Technical Bulletin

Bulletin No: TCH-013-007

Subject: **Bendix® EC-30T™ ECU Product Recall Campaign**

The Cause

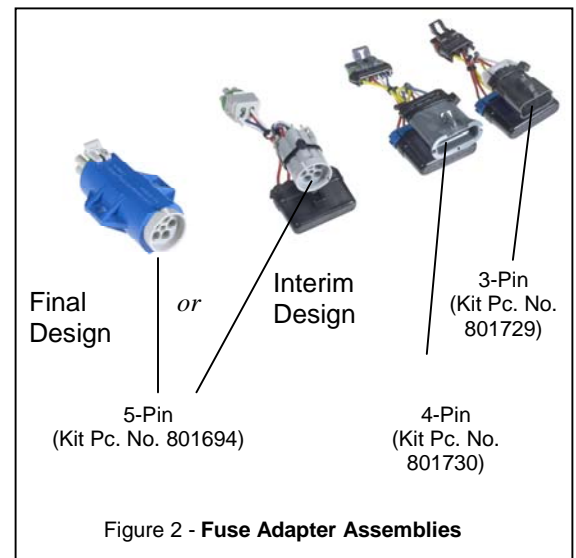
Bendix has determined that if the trailer-mounted ABS warning lamp circuit experiences an electrical short for reasons unrelated to the EC-30T, and the short is not repaired, the high side power switch inside the ECU may eventually become thermally stressed and experience an electrical short. The high side power switch controls the illumination of the trailer-mounted ABS warning lamp.

If the power switch shorts, it can result in an over-current condition in the ECU and lead to excessive heat, smoke and in rare cases, even fire in the ECU, the connector or the pigtail wiring harness. The fire that could result from this situation involves an unreasonable risk to motor vehicle safety. The service, parking and emergency braking of the trailer and tractor are not affected by this condition.

The electrical short must occur in the wiring between the ECU and the warning lamp. Failure cannot be caused by any wiring defect on the ground side of the warning lamp.

All vehicle manufacturers, dealers and distributors should stop selling any EC-30T or MC-30 that does not include an MC-30 Fuse Adapter Assembly. Please make your customers aware of the recall campaign. All new EC-30Ts and MC-30s will be shipped with an MC-30 Fuse Adapter Assembly.

If your current inventory contains MC-30 or EC-30T, an MC-30 Fuse Adapter is required for installation. Fuse adapter kits are available in 3, 4 and 5-pin configurations. To identify the correct piece number needed check the connector of the pigtail harness that connects to the chassis harness. See figure 2 for kit piece numbers. To order the MC-30 Fuse Adapter Kit, please call the Recall Assistance Center at 1-800-478-1793 between 8:00am to 5:00pm E.S.T.
